**TO:** Amy Hodgen (Statutory Planning)  
**FROM:** Blake Farmar-Bowers (Open Space) and  
Christian Lundh (Urban Design)  
**DATE:** 7 August 2020  
**SUBJECT:** 60 Chandler Highway, Alphington  
**APPLICATION NO:** PLN19/0606  
**DESCRIPTION:** Construction of residential development 60 Chandler Highway in Outer Circle Precinct (Precinct 6) of the Alphington Paper Mills development. The application seeks to construct a multi-unit development ranging in height between 5 – 8 storeys, vehicle access, car parking, public accessible private landscape areas, roof top terraces and a wellness centre with associated pools, gym and other recreational facilities.

- YarraBend, Alphington Town Planning Report (landscape report) dated 16 July 2020 REV D prepared by ASPECT Studios; and
- 18022 - 60 Chandler Highway, Alphington, Town Planning RFI Submission Drawing Set, received 16 July 2020 prepared by Elenberg Fraser.

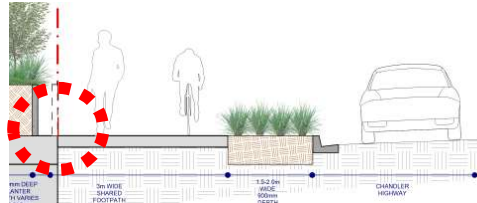
- Confirm pavement / treatment of the sliver of land between the planterboxes / site boundary and the SUP, highlighted in streetview image below.
  - Is there opportunity to shift the planterboxes further towards the site boundary to maximise them while retaining the architectural design intent?
  - Noting that current configuration has exposed underground roof slab along the SUP, delineation detail required.

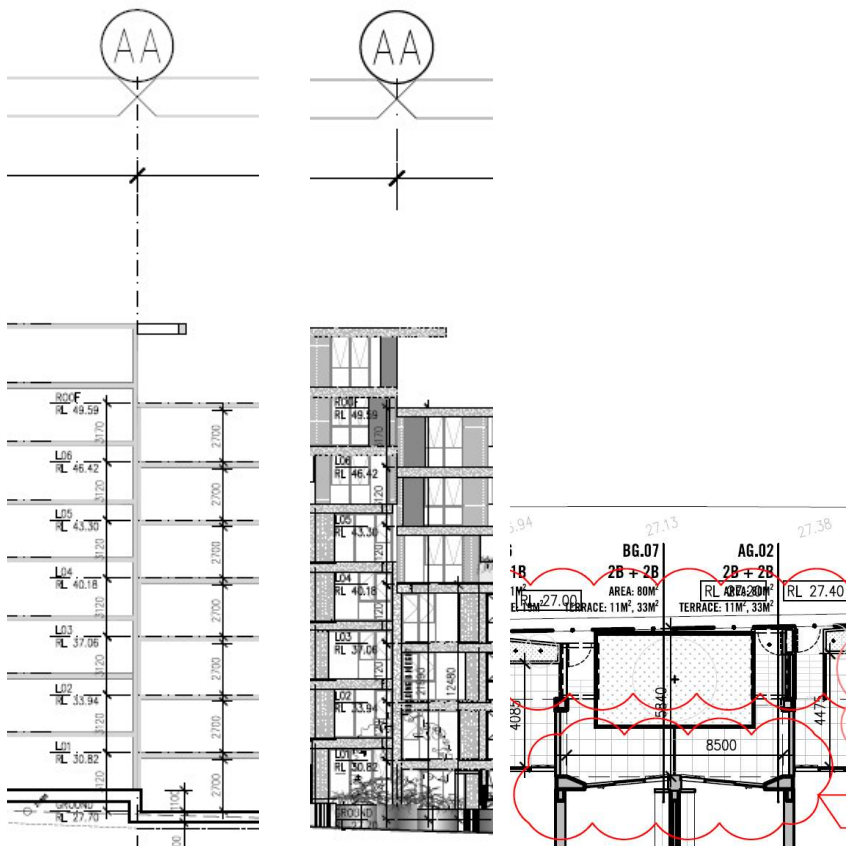
Clarification regarding the interface treatment along the property boundary is required. Garden beds are shown in all new architectural renders, while this interface is shown as exposed basement roof slab in landscape plans / sections as well as the architectural sections.

Clarification required regarding the stepped basement roof slab, including but not limited to; extent in relation to assumed deep planter boxes with large trees and demonstration that a seamless and compliant level transition along the SUP will be achieved.

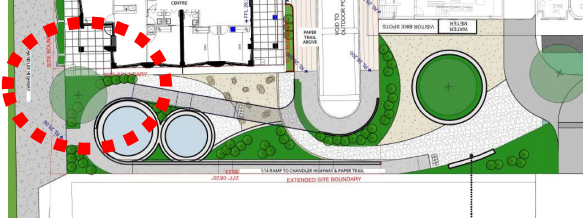
- The proposed tree species; *Corymbia maculata* is in accordance with the Development Plan. Provide further details in regard to proposed soil volume, suitability for this species to grow in container and future tree management.
- Soil volume provided for each tree planting area.
- The proposed *Ulmus parvifolia* is not supported by the entrance thresholds to the ramp. Suggested substitution with *Corymbia* sp. to link in with the Chandler Hwy tree species character.

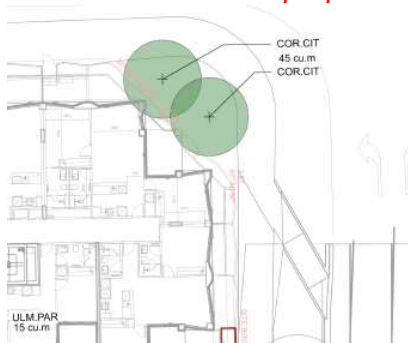
- Coordinate with the adjacent streetscape package to ensure that the proposed trees shown highlighted below are positioned to maximise their growing opportunity and amenity for future residents.
  - The proposed trees shown in corner garden bed by Mills Blvd are supported. Suggested investigation if there is adequate space and soil volume for a third tree in this location.
  - Confirmation if these trees will be included in the overall Mills Blvd Landscape works, as plan annotation notes “All public realm treatment outside the project site for illustrative purposes only.”

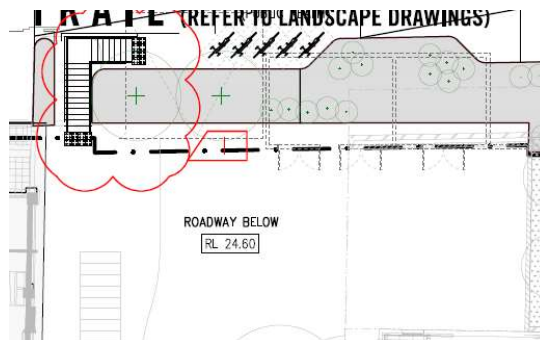
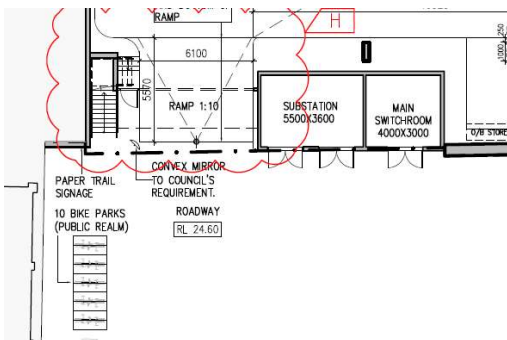
- Access and circulation
  - Paper Trail noted to facilitate both pedestrian and cycle use. Review potential conflict points. Refer to integrated transport plan page 34 (screenshot below), where the Paper Trail is identified as a shared path.

For reference, an example of the potential approach to the configuration of the cyclist and pedestrian space on La Trobe Avenue is shown in Figure 4.6.

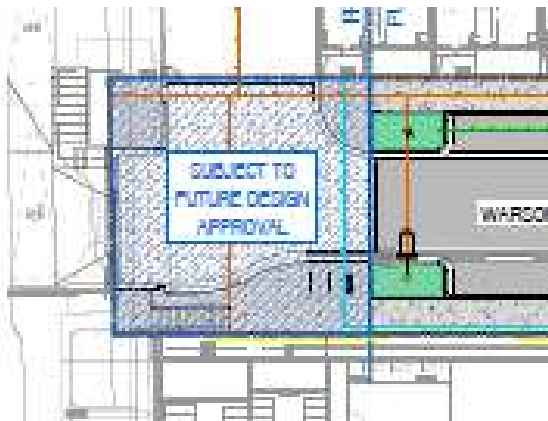
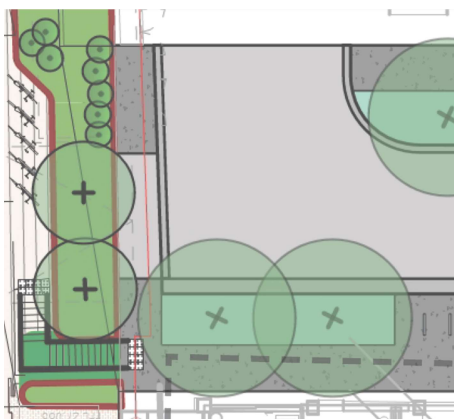
A greenwall now shown, further clarification required of area shown in screenshots below (provide screenshots from architectural models if possible) including but not limited to; carpark ramp/under croft, relationship to Wetlap/The Mills and other adjacent developments.

Warsons Place streetscape not shown correct. Refer current Workshop Precinct Package for most current layout, refer screenshot to the right below.

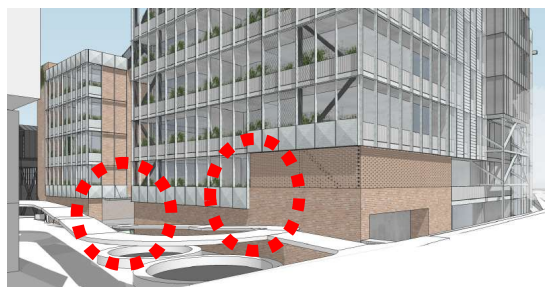
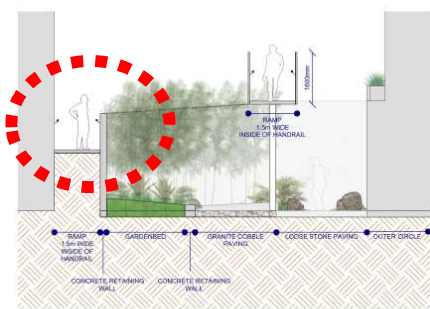
- Concerning that there is no contingency in relation to the offset from the adjacent interface to the Boiler House development, considering the ramp will facilitate both pedestrian and cycle use and achieving a minimum clear width of 1500mm is crucial. Ensure all handrails and tactiles are shown and are located within title boundaries.

- An unobstructed ramp width of 1500mm is required for 'Curved walkways, ramps, and landings'. Given this ramp is contending with cyclists is there opportunity to increase the unobstructed width of the ramp to 1800mm? This would help to mitigate potential conflicts for example when a bike is coming down the walkway and person(s) walking up?
- Ramp shown 'flush' with the Boiler House development, with handrail fixed to Boiler House façade.
- How will construction of the ramp and handrail/balustrade be coordinated and integrated with Boiler House? Is there any construction tolerance to achieve required width?
- Section of protruding window may present as a potential conflict. Review section interfacing with Boiler House courtyard for balustrade / kick-rail requirements.

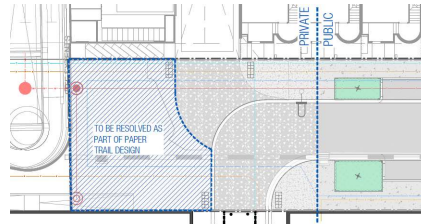
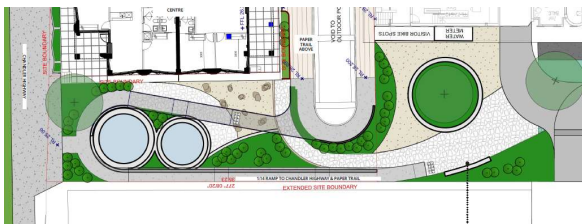
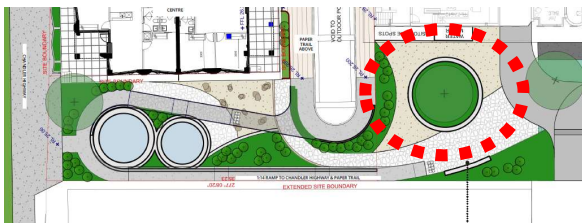
- Concern regarding the termination of the ramp by Joels Terrace and its proximity to the main entrance to the car park, lack of visibility coming down from the ramp and potential risk for conflict / collisions.
  - We support the curved ramp ending on an angle. Further clarifications required including but not limited to full coordination with adjacent developments and streetscapes.
- Coordinate interfaces and design with adjacent landscape and other relevant disciplines drawings.
  - Further coordination required, refer current Workshop Precinct Package for most current layout (screenshot to the right below).

- The proposed feature Maple tree is not supported, as this location is one of few locations within in the precinct that would accommodate for a large canopy tree.
  - The noted soil volume available in this area is 37 cu.m, which presents an opportunity to nominate a much bigger tree than the *Ulumus* ssp proposed. Review tree species selection.

- Concern regarding potential gravel spill from the extent of white loose stone paving shown.
  - Confirmation of title boundary/ in relation to proposed bespoke materials.

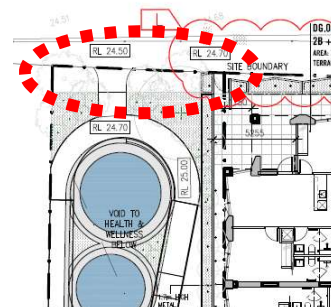
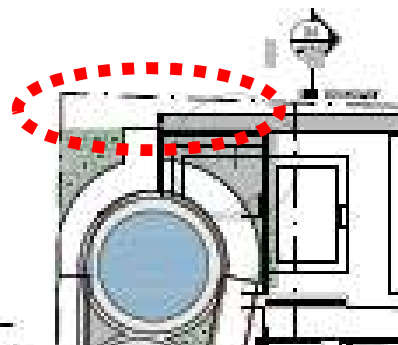
Current architectural drawings illustrate the presence of basement walls, see screenshots below. Clarify how the extent of architectural basement roof slab / walls will be integrated/concealed at this threshold.

Confirm soil volume for the proposed tree.

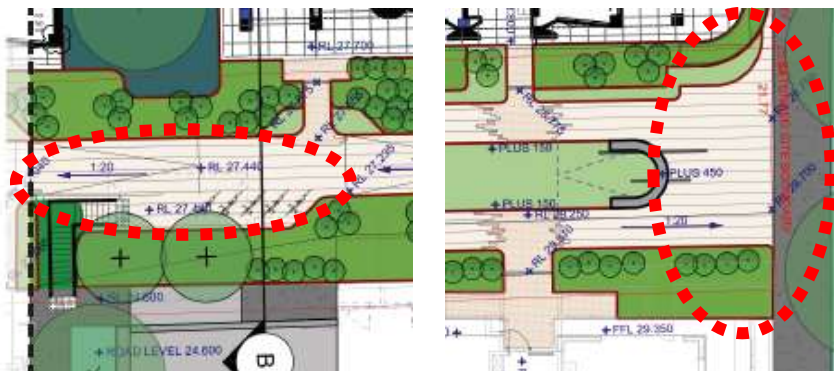
- *Ensure suitable clearances are provided for all bicycle hops (500 x 1800mm each side).*  
**Placement of bicycle hoops is suggested to be reviewed including but not limited to screenshots below. (Proximity to ramp and stairway and circulation around void).**

**Levels requires further resolution, including but not limited to areas shown in screenshots below; By the proposed stair landing / interface to ramp and by the 'ramp' interface to Mills Blvd.**

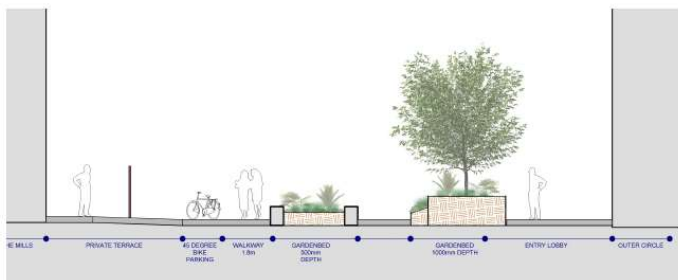
- Depths of garden bed for low planting.
- Sloped garden beds as shown below are not noted on plans. Impacts volumes of garden beds (show depth of podium/structure).

Soil volume provided, confirmation on how calculation is generated is required as nominated height of planter boxes is assumed to also include subsurface drainage, mulch layer etc.

Sectional Elevation A - Paper Trail Typical Walkway (Scale 1:100 @A3)

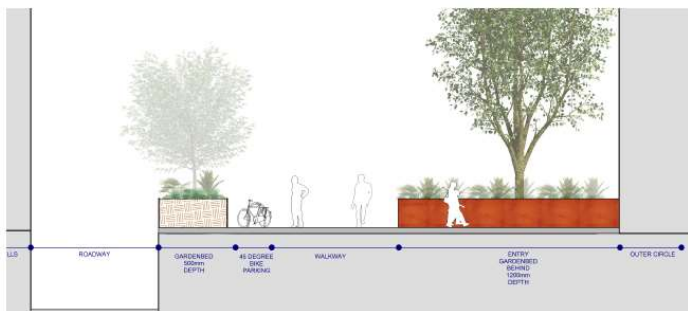
Additional information required including but not limited subsurface drainage layers.

Podium sections need to illustrate coordination with structural design to ensure landscape vision is feasible.
